RE: COUNTRY SQUIRE MHP
OEPA PERMIT # 3PV00130
COMPLIANCE EVALUATION INSPECTION
S.R. 62 AND KNOX SCHOOL ROAD
KNOX TOWNSHIP
COLUMBIANA COUNTY

NOTICE OF VIOLATION

JANUARY 27, 2010, INSPECTION PHOTOS

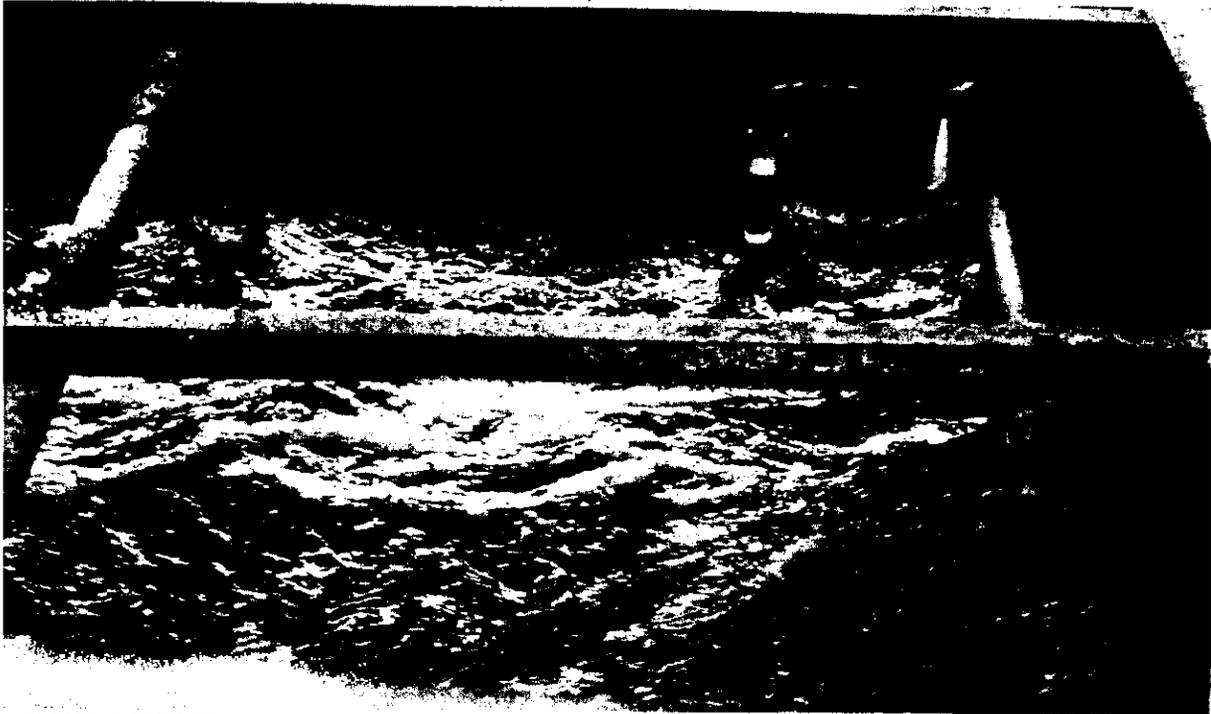
SOME OF THE DIFFUSERS ARE INOPERABLE AND MAY NEED CLEANED

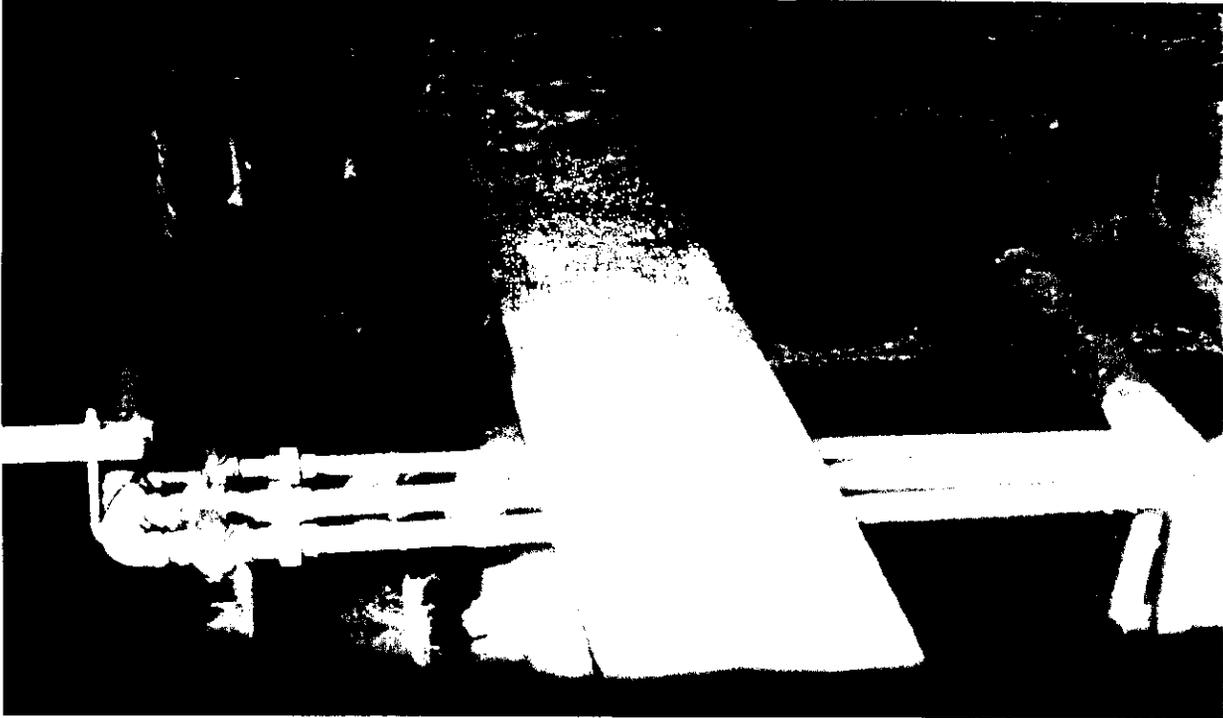
SOLIDS GOING OUT THE EFFLUENT WIER
